AREAS OF MODIFICATION BETWEEN APPROVED DRAINAGE GRADING PLAN AND ACTUAL AS-BUILT

MOUNTAIN STATES MUTUAL CASUALTY GROUP

JOURNAL CENTER
VHGA PROJECT NO. 918

DRAINAGE / GRADING PLAN

DRAINAGE / GRADING PLAN
SCALE: 1"=30'

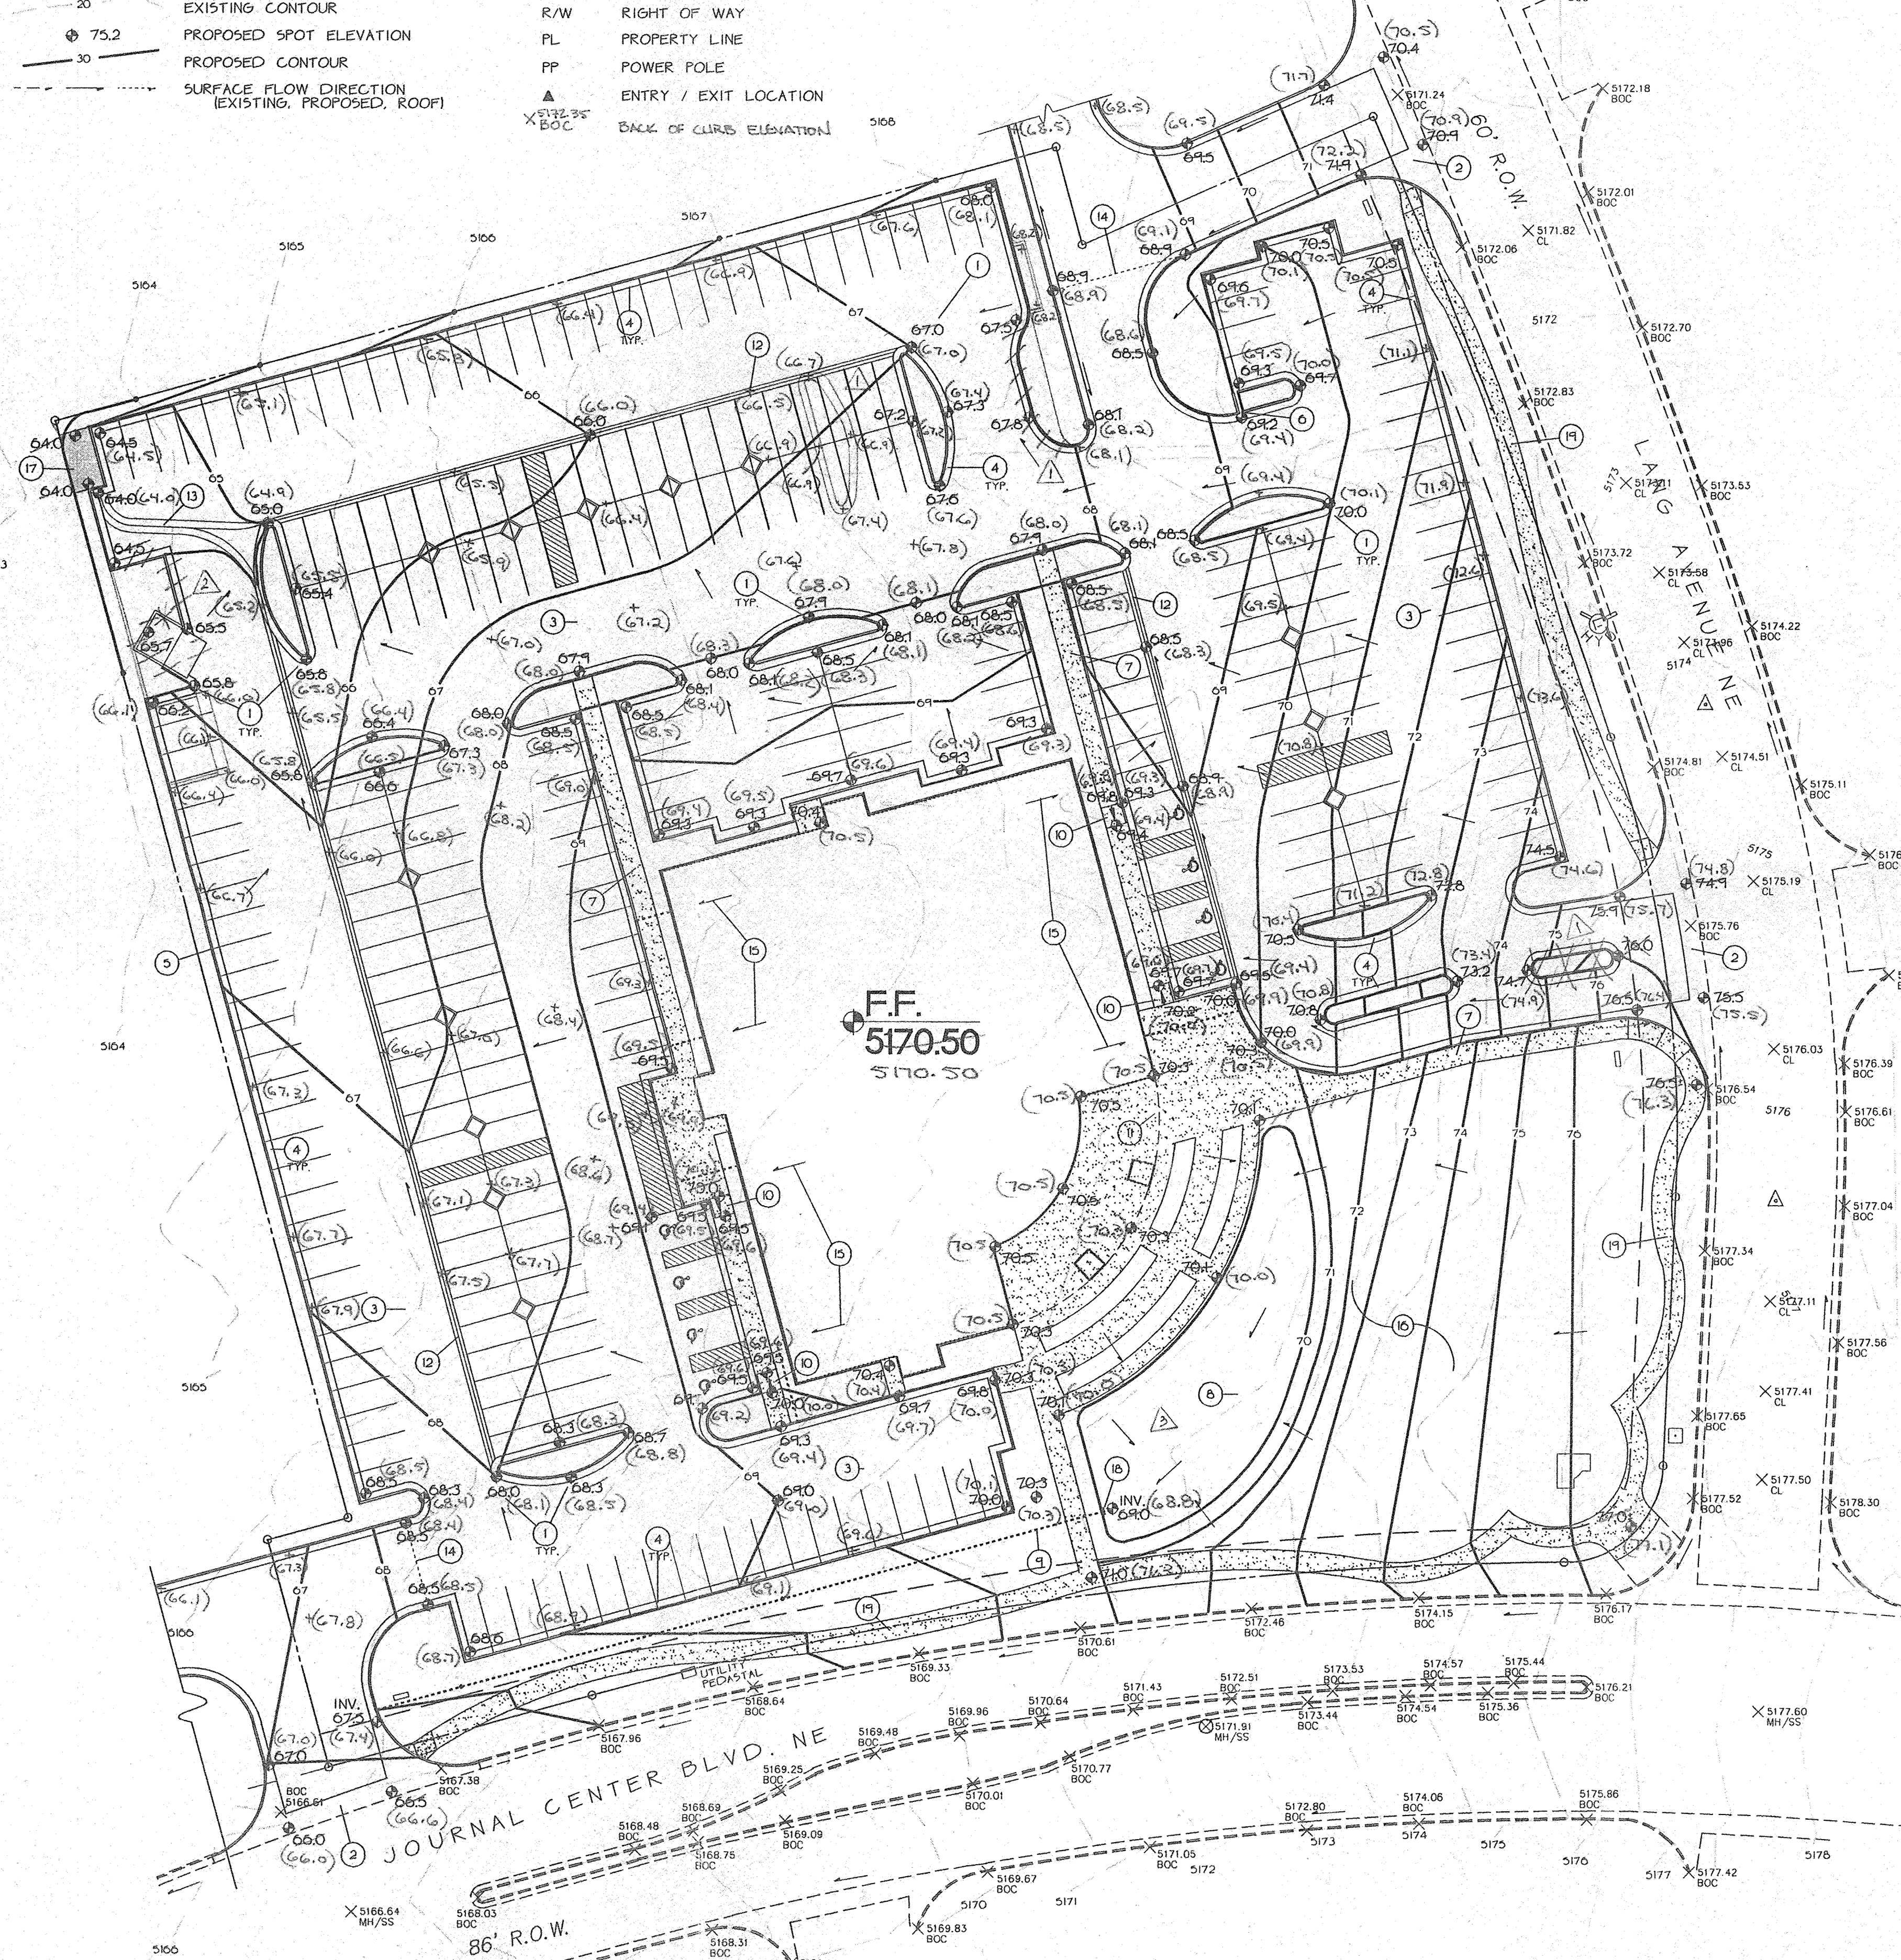
- Minor changes to curb and gutter / island locations. Does not affect drainage patterns. OKAY.
- Dumpster relocated. OKAY.
- As-built Pond Volume = 2350 SF Required Pond Volume = 1305 SF

I, Christopher L. Weiss, P.E. hereby certify that the as-built information shown, is in substantial compliance with the approved drainage / grading plan.
